**AMENDED ACTION MEMORANDUM  
TIME-CRITICAL REMOVAL ACTION FOR THE PCB HOT SPOT  
AREA AT PARCEL E-2-REVISION 2009  
*Hunters Point Shipyard  
San Francisco, CA***

***DCN: SHAW-8822-0005-0042.A1***

***September 17, 2009***

Subject: Amended Action Memorandum  
Time-Critical Removal Action for the  
PCB Hot Spot Area at Parcel E-2-Revision 2009  
Hunters Point Shipyard  
San Francisco, California

**FIGURE A-2  
 SITE FEATURES MAP**

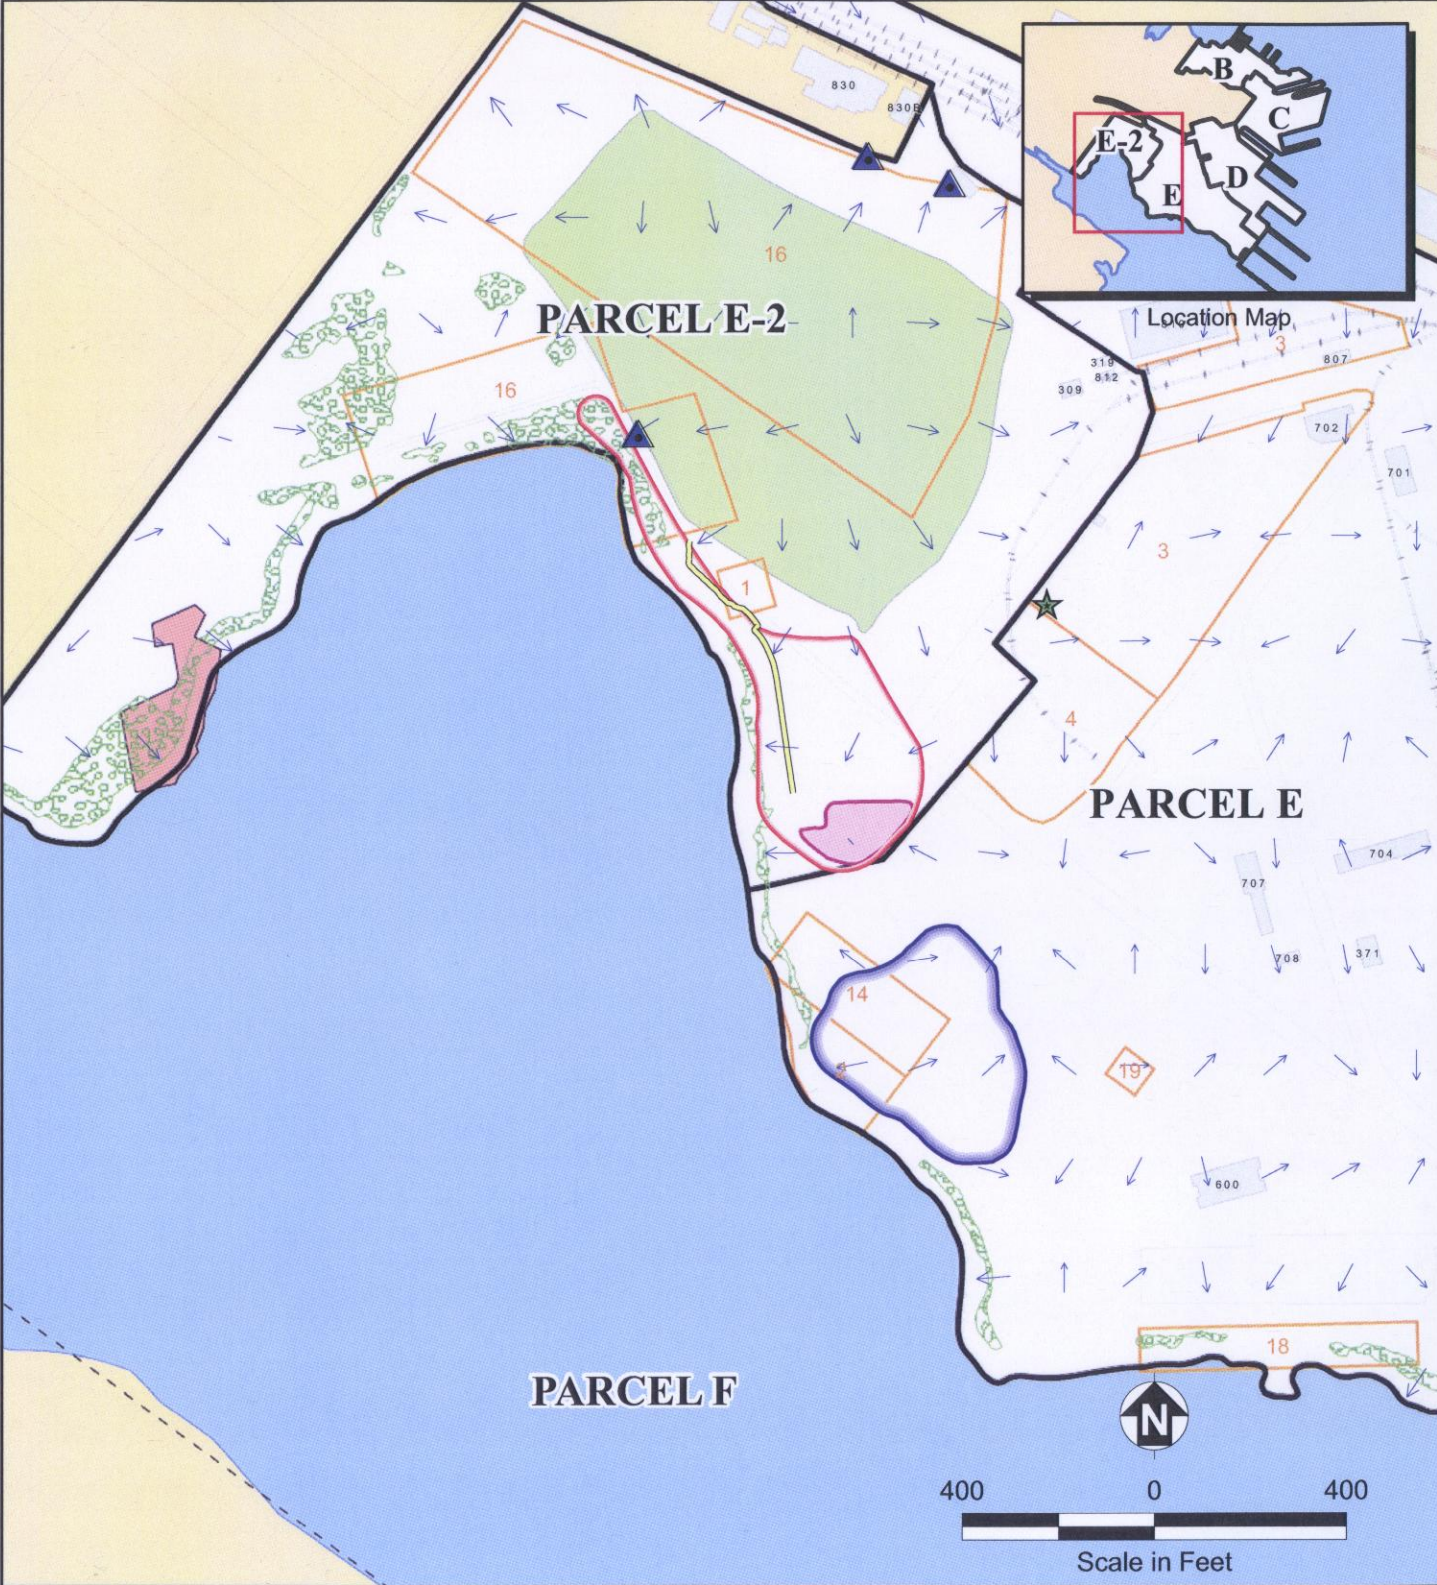
3. **Comment:** Section 1.0, page 2, Section 2, page 11, Figure A-2: The PCB Action Memo states that as part of this Time-Critical Removal Action (TCRA), soils with PCB concentrations exceeding 1 part per million (ppm) will be excavated and appropriately disposed of offsite. The excavation will be backfilled with clean soil thus creating a 3-foot cover. Figure A-2 shows a plan view of the sampling locations where PCB concentrations exceeding 1 ppm exist in soil between 1 and 3 feet below ground surface and the proposed excavation boundary.

- The elevation contours projected on Figure A-2 show ground elevations within the excavation footprint ranging from about +12 ft to approx. 1 ft above sea level;
- There appear to be no sampling points located outside the excavation footprint that meet the 1 ppm remediation goal (define the lateral limits of excavation);
- There appear to be no sampling data located within a significant middle/southern portion of the excavation to steer the proposed TCRA;

- There is no depiction of the vertical distribution of the PCB hot spot either via cross section and/or data postings (spider diagrams, etc); and,
- The PCB hot-spot excavation appears to fall within the general location of the proposed sedimentation area (Figure 4, Drainage Patterns and BMPs at IR-01/21, September 30, 2004 Storm Water Discharge Management Plan, Industrial Landfill, Parcel E2).

**Response:** A new figure (titled Figure A-2) was added to show the PCB hot spot in relation to surrounding Parcel E and E-2 features, including the Installation Restoration Site (IR)-02 Northwest and Central removal area (radium dial disposal area). Based on existing data, continuous PCB contamination does not extend into the IR-02 Northwest and Central removal area; however, soil surrounding two borings within the IR-02 Northwest and Central removal area will be removed because PCB concentrations at the two borings exceed 100 ppm. The proposed pre-excavation sampling will define the extent of PCB contamination. Section I was revised to state that two borings within the IR-02 Northwest and Central removal area will be removed as part of the PCB hot spot removal action.

- Response:**
- (a) Appendix A has been revised to include a new figure (Figure A-2) that depicts the location of the suspected source (Triple A Machine Shop, Inc. site), surface flow directions, discharge points, the formerly proposed sedimentation basin, and the location of the radiological removal action (see EPA General Comment 4) relative to the proposed PCB excavation footprint.
  - (b) The details requested by the Water Board staff are addressed in the TCRA work plan, which contains a storm water pollution prevention plan (Tetra Tech ECI 2005a); these details are not typically provided in the Action Memorandum. Section I of the Action Memorandum was revised to state that specific construction details for implementing the TCRA, including sediment transport control measures, are presented in the TCRA work plan.
  - (c) Please see the response to (a) above.

**Response:** The PCB hot spot area is located adjacent to and southeast of the landfill. A new figure (Figure A-2) is now included in the Action Memorandum that shows other site features, including the landfill, in relation to the PCB hot spot area.

**Response:** The DON will be conducting a radiological removal action in IR-02 Northwest and Central concurrently with the PCB hot spot TCRA (see Figure A-2). If radiological material is encountered at the PCB hot spot removal area, it will be removed.

**FIGURE A-3**  
**PROPOSED EXCAVATION AREA**  
 Action Memorandum  
 Time-Critical Removal Action for the  
 PCB Hot Spot Area at Parcels E and E-2

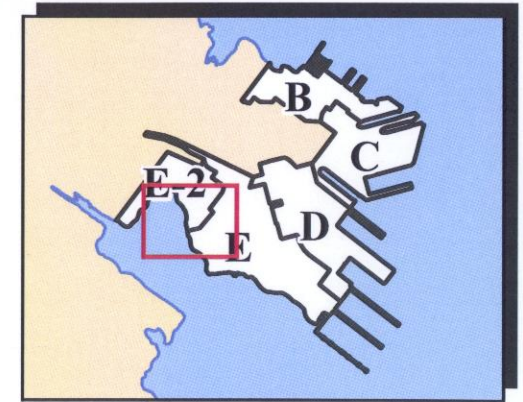
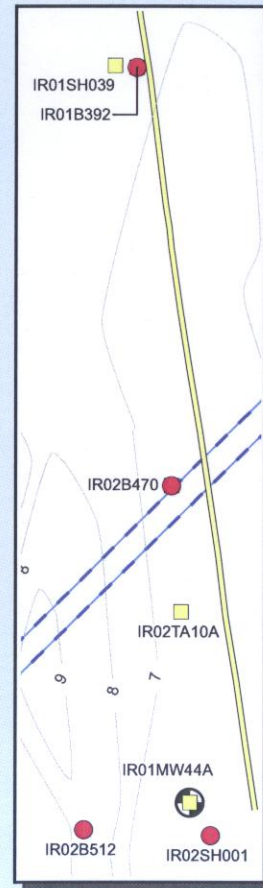
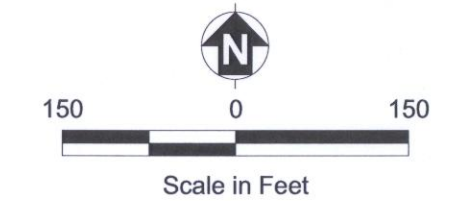
3. **Comment:** Based on Figure A-2 and on the data table with PCB concentrations subsequently provided by the DON, only 3 of 23 locations along or near the proposed excavation boundary are below the proposed 1 ppm cleanup level, so it is unclear how the proposed excavation boundary was determined. The proposed action includes delineation of the extent of PCB contamination; if the extent of contamination is greater than estimated, the cost of this removal action could be impacted. Further, it is unclear what actions will be taken if contamination is found to extend into the intertidal saltmarsh (wetlands) or into the off-shore areas. Please explain how the proposed excavation boundary was determined and discuss whether there are any limitations on the size of the excavation that can be completed under this action. Also, please discuss the potential that contamination will extend into the wetlands or offshore and what will be done if that occurs.

1. **Comment:** Section II.A.4, Release or Threatened Release, Page 5 and Section II.A.5, Maps, Pictures, and Other Graphic Representatives, Page 6: The text states that the concentrations of PCBs are included on Figure A-2, but this information was not provided. EPA Action Memorandum Guidance (EPA/540/P-90/004, 1990) states that when PCBs are of critical concern, the substance, quantity, location, and existing standards should be included in chart format. Please include PCB concentrations in a data summary table in the Action Memorandum or include these concentrations on Figure A-2.

The DON evaluated all available data when developing the draft Action Memorandum, including the SDGI data. Section II.A.1 and Figure A-3 (formerly Figure A-2) were revised to include information about recent PCB data.

**Response:** The focus of the TCRA is the PCB hot spot area shown on Figures A-2 and A-3 of the Final Action Memorandum. The proposed excavation boundary shown on these figures was determined using existing PCB soil data. The proposed pre-excavation sampling results will be used to refine the extent of PCB contamination. The TCRA may involve excavation within nearby wetlands but will not involve offshore excavation.

**Response:** Figure A-3 (formerly Figure A-2) was revised to include PCB concentration information.
